**CMD 25-H9.15**

**Written Submission from the  
Ya'thi Néné Lands and Resources  
Office**

Licence Application to Prepare Site and  
Construct for Denison Mines' Wheeler  
River Mine and Mill Project

# YA'THI NÉNÉ LANDS AND RESOURCES INTERVENTION

**FIGURE 1: MAP SHOWING EXTENT OF MINERAL DISPOSITIONS AND ACTIVE PERMITS WITHIN NUHENÉNÉ AS OF SUMMER 2025**

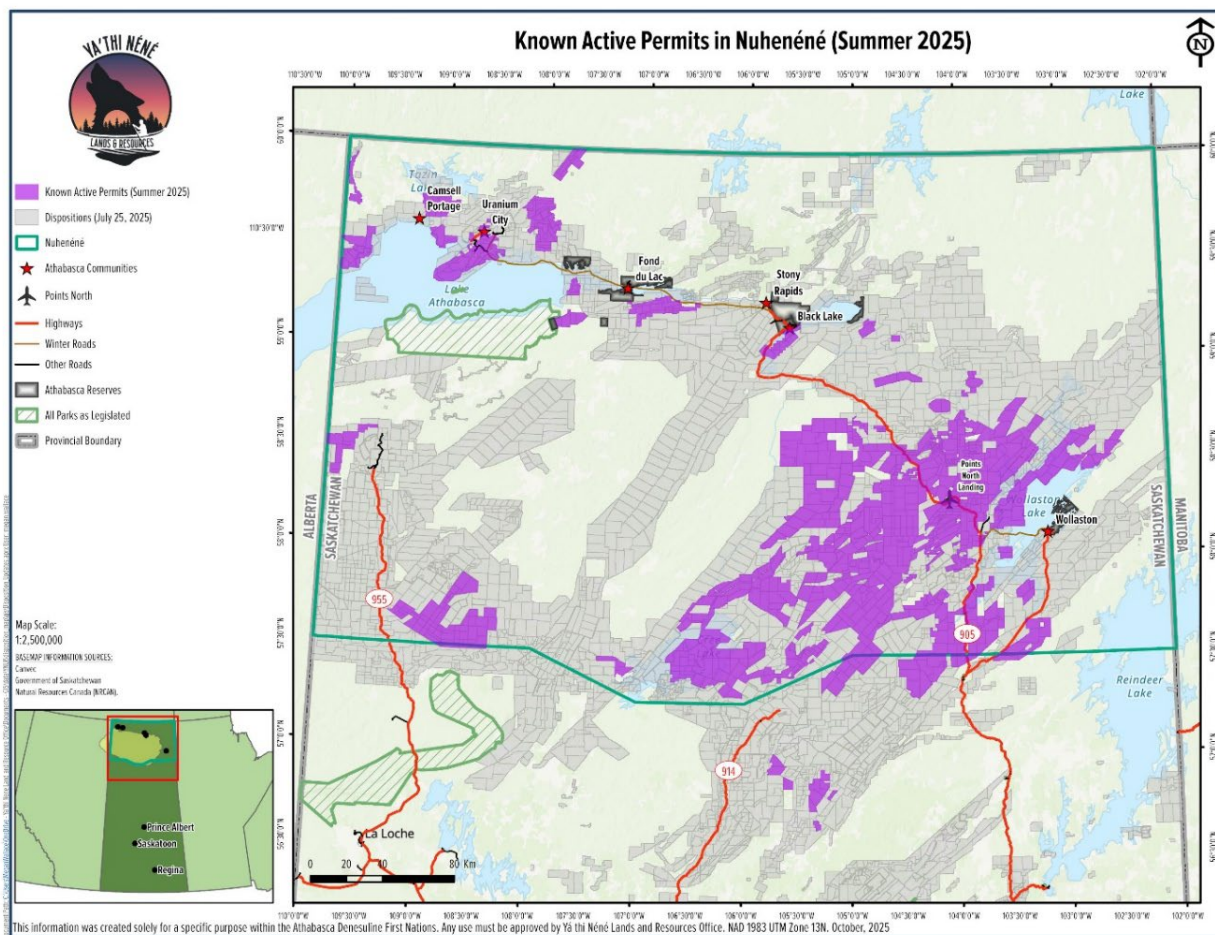
We retain our concern regarding cumulative effects. As noted by the CNSC, the total extent of human disturbance was not sufficiently factored into the assessment analysis. Our own estimate shows that the total amount of known linear disturbance within Nuhenéné is more than 20,400 km and growing.

Furthermore, looking into the future, the total number of current mineral claims and exploration activity is also increasing rapidly (see Figure 1).
